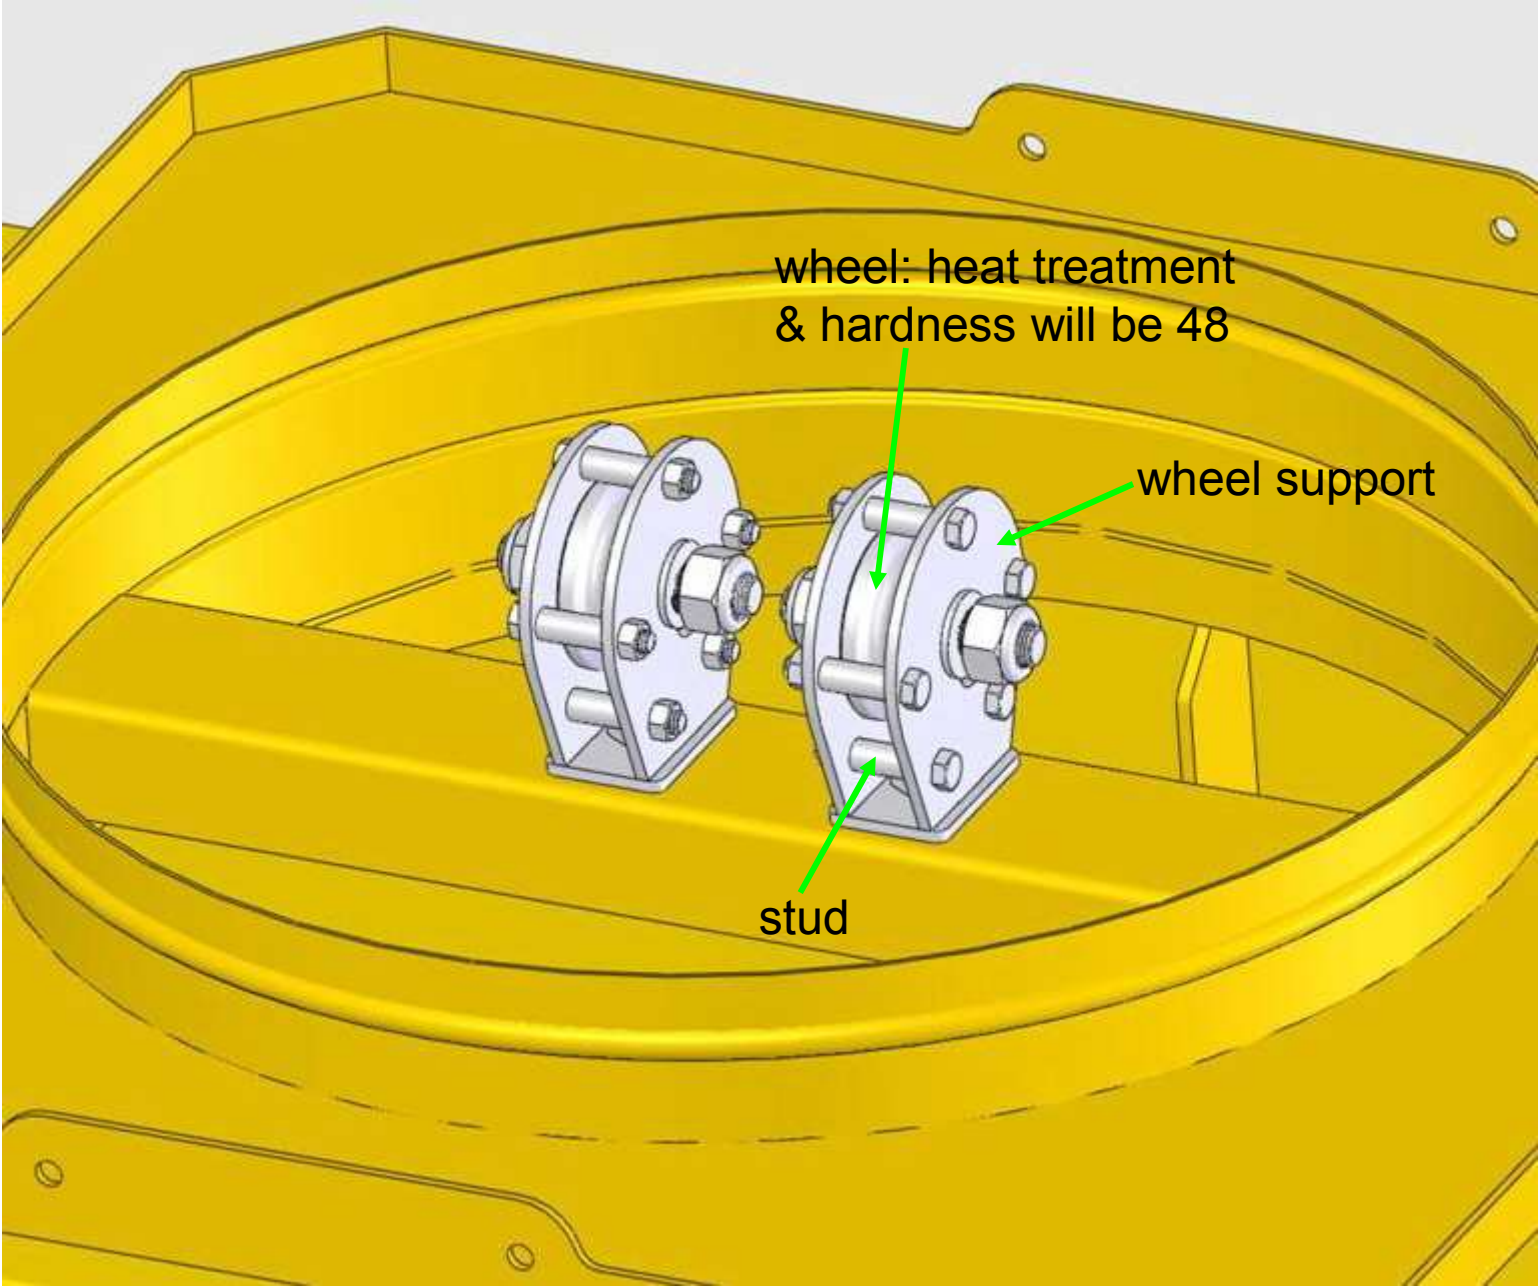
1. cable changed from 5mm to 6mm

2. add (3) 3/8" studs to prevent the cable from coming off from the wheel

3. lock washer and lock nut

wheel: heat treatment
& hardness will be 48

Will manufacture #1 and #2 to stimulate the situations of using the cables holding the hood and lowering it to hit something. Make sure that the cable will not come out of the wheels.

The test will be processed to run 24hrs a week. Afterwards, these parts will be sent out for local inspection to check if they are worn out or not.

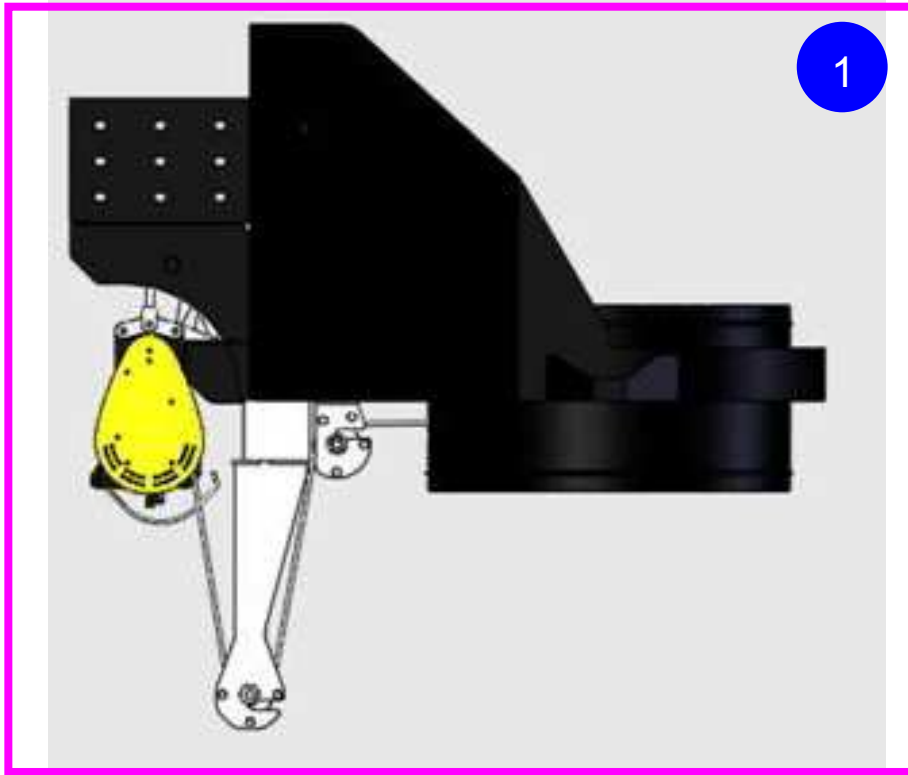
stud
